Owner: Otto Gebhardt, Gebhardt Development  
Project Name: the Galaxie Phase I & II  
Purpose: UDC Design Progression Submission

Location: East Washington Avenue, Madison WI  
Architect: Midwest Modern, LLC

Following is a description of the project design progression as it has evolved from previously approved submittals. Please consider the additional descriptions below in your evaluation of their impact on the overall design of the project.

**UDC RESUBMITTAL**

1 PROPOSED ENLARGED PARTIAL EAST WASHINGTON STREET ELEVATION  
 1/16" = 1'-0"

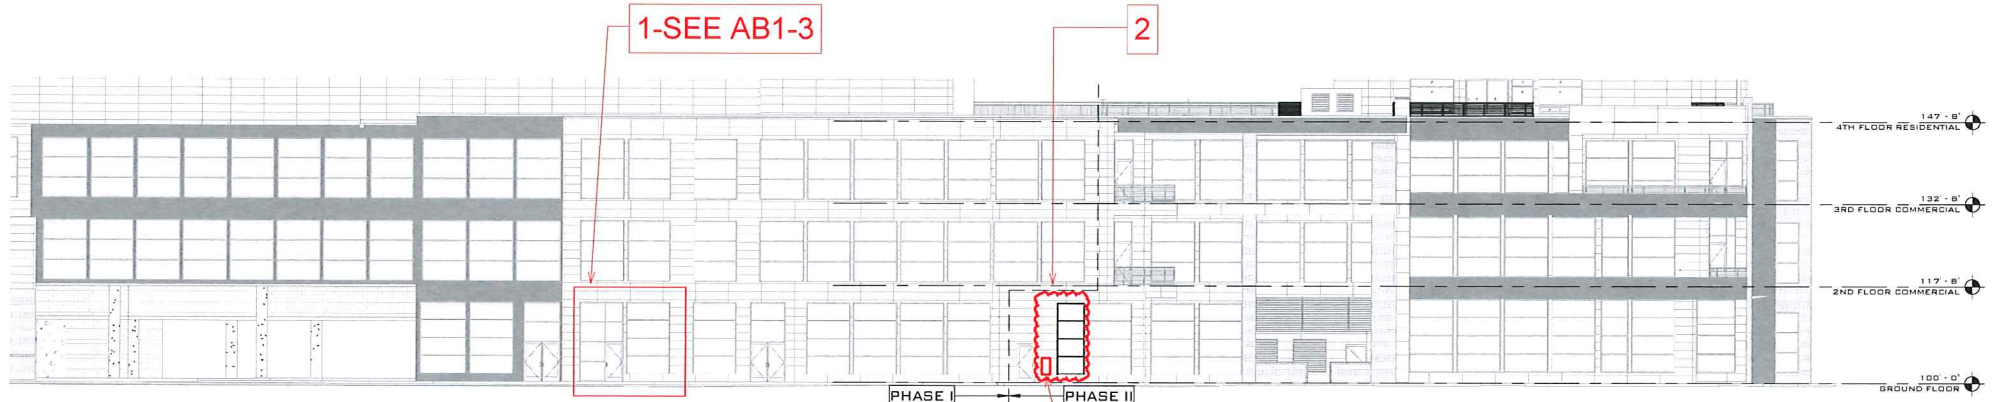
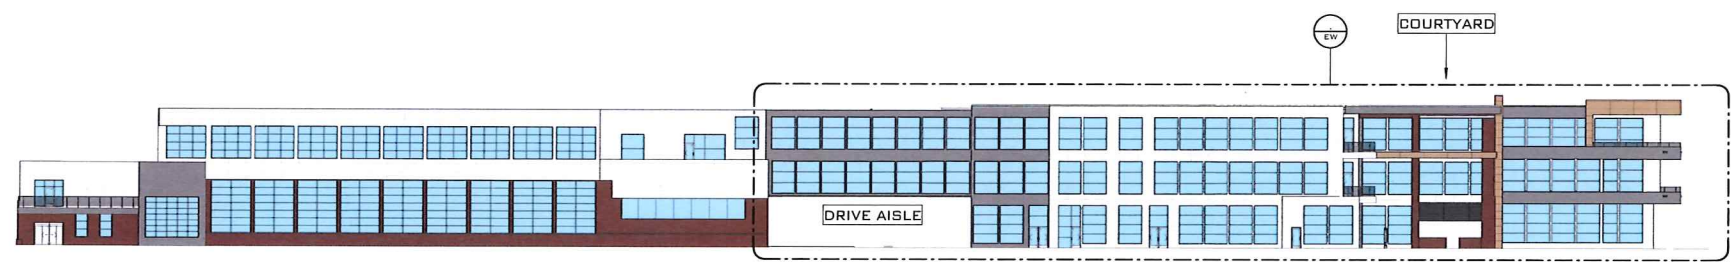
1. Tenant entry fenestration and door alteration at Associated Bank tenant space. Addition of ATM and night deposit box within anodized aluminum frame.

Associated Bank (AB) will be occupying space on the Ground and 2<sup>nd</sup> floors of the Galaxie Phase I commercial space along East Washington Avenue on either side of the commercial lobby stair. AB is proposing to flip the orientation of the door and storefront glazing at their ground floor entry and to install an ATM and night drop into the storefront frame system. Two of the glazing units will be replaced by a composite anodized aluminum panel that the ATM terminal and night drop will be installed within. The panel will match the finish of the surrounding clear anodized aluminum storefront frame. The glazed area on the East Washington façade will be reduced by two glazing lites, but the requirement of 60% window at ground floor will be reduced from 61% window to 60% window. The storefront is being flipped to allow AB to access the stair directly from their ground floor suite, and provide a circulation route into the space without traversing around the ATM and night box installation. The previously proposed lightbox that displays the AB logo is now being proposed to be a painted wall with smaller AB tree logo and text. The painted wall will be set back from the exterior storefront 4 feet.

2. Revise approved storefront to accommodate fire department connection at transition between phases I & II.

- PROPOSED ITEM KEYNOTES:
1. REVISE ASSOCIATED BANK STOREFRONT/ATM/NIGHT DROP
  2. REVISE STOREFRONT @ FIRE DEPT. CONNECTION
  3. ADD LOUVERS AT ENCLOSED PARKING GARAGE FLOORS
  4. ENLARGE RESIDENTIAL BALCONIES AT PHASE II 4TH FLOOR
- (SEE COVER LETTER FOR ADDITIONAL INFORMATION)
